Technical Advisory Committee

FILE NO.: 24-DP-02
APPLICANT: 2022 Mayo LLC
LOCATION: 1835 Fletcher Street
REQUEST: Site Plan and Design for a 15-unit residential development.

Preliminary Site Plan Review

6 VUA PLAN
1" = 30'-0"

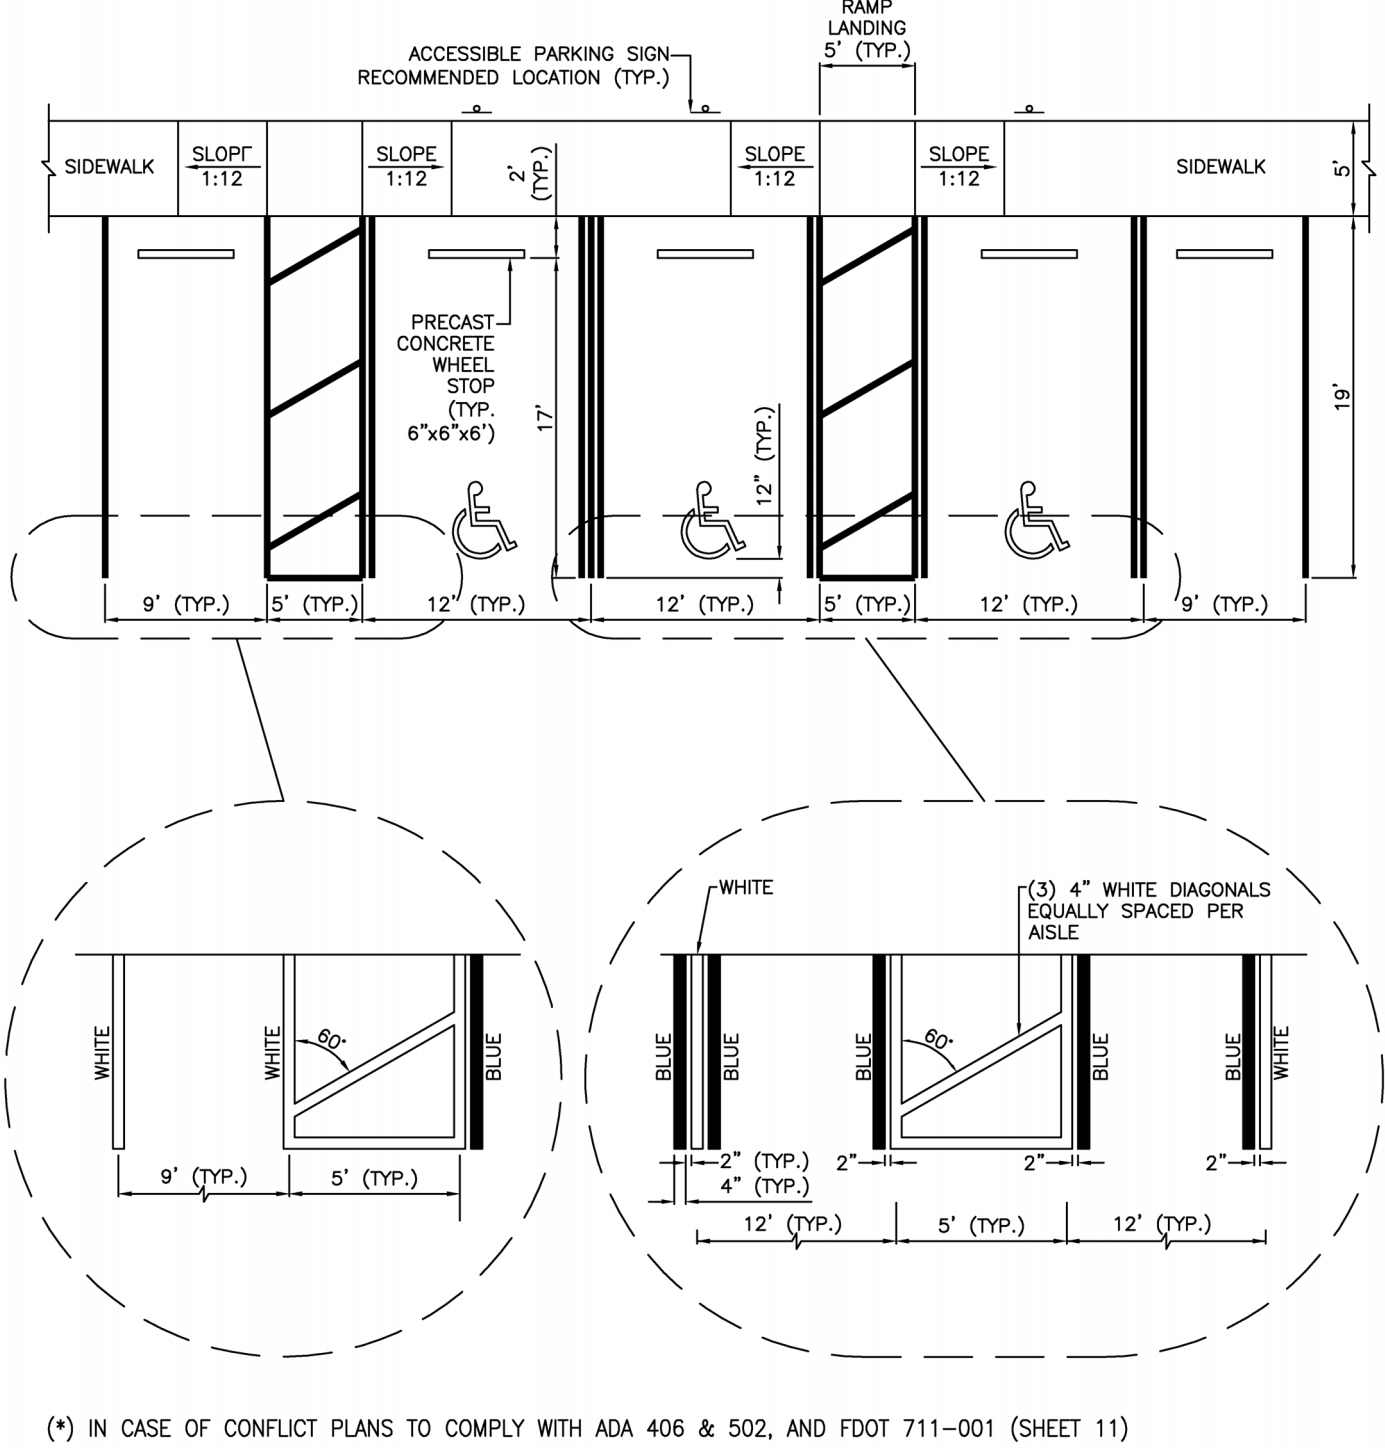
e. Provide VUA calculation. Please see section 4.6(3)(d)(3) of the code.

Response: Provided, refer to Sheet SP-1.2

8 DUMPSTER ENCLOSURE DETAIL

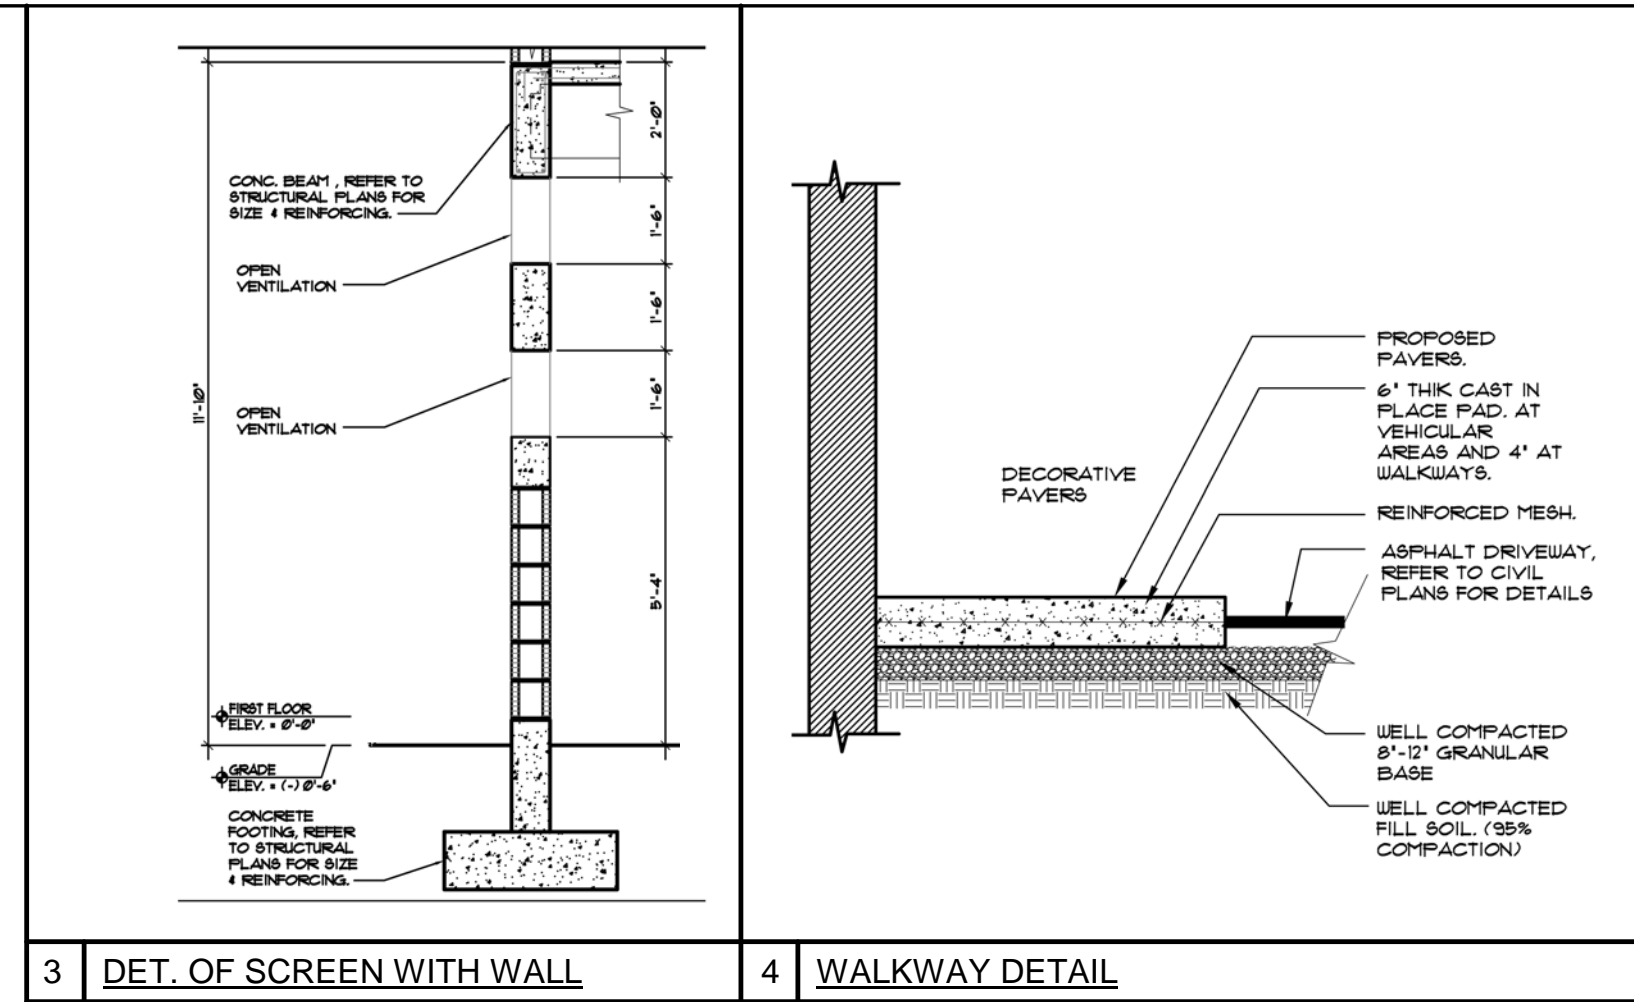
2. Indicate and demonstrate access to the dumpster on site plan.

Response: Provided, refer to sheet SP-1.1
